Serial No.: 10/617,466

Amendments to the Drawings

Remarks/Arguments

Fig. 1

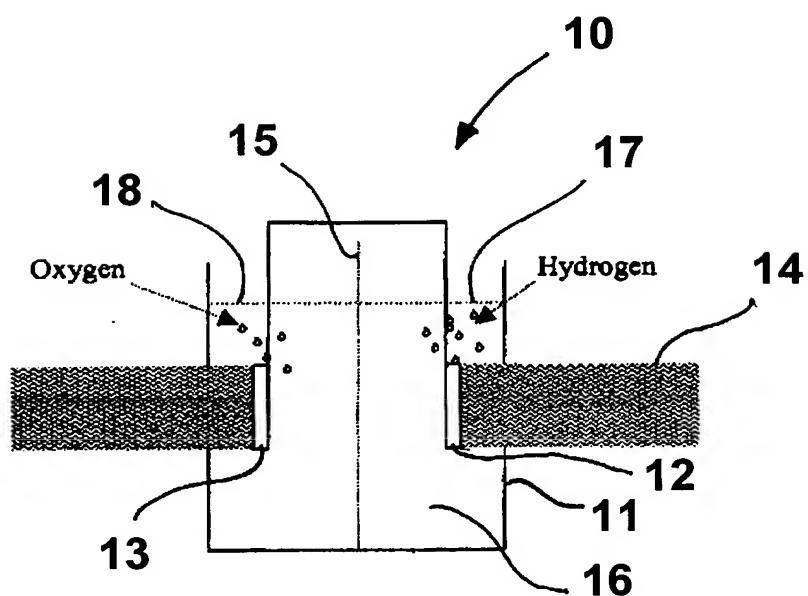
Fig. 1 has been objected to for failing to provide a legend to indicate that it shows only that which is old subject matter. In response, Applicant has added the label “Prior Art” to Fig. 1.

The attached sheets of drawings include changes to Figs. 1, 2 and 3. These sheets replace the original sheets of Figs. 1, 2 and 3. In Fig. 1, the label "Prior Art" has been added; in Figs. 2 and 3, the reference character 28, which previously designated sunlight, has been changed to reference character 14.

Label added

Fig. 2

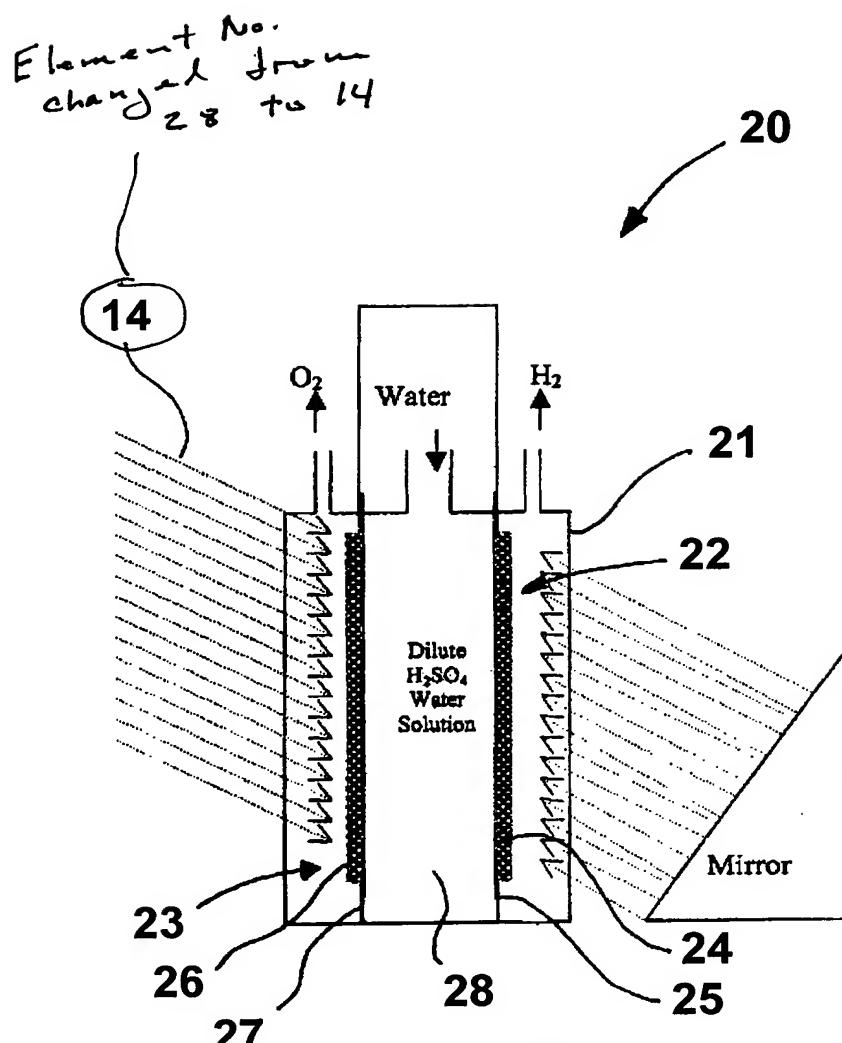
The drawings have been objected to as failing to comply with 37 CFR 1.84(p)(4) because the reference character "28" has been used to designate two elements, sunlight and electrolyte, in Figs. 2 and 3. In response to this objection, Applicant has amended the drawings to utilize reference character "14" to designate sunlight, which is consistent with the designation of sunlight shown in Fig. 1. To the
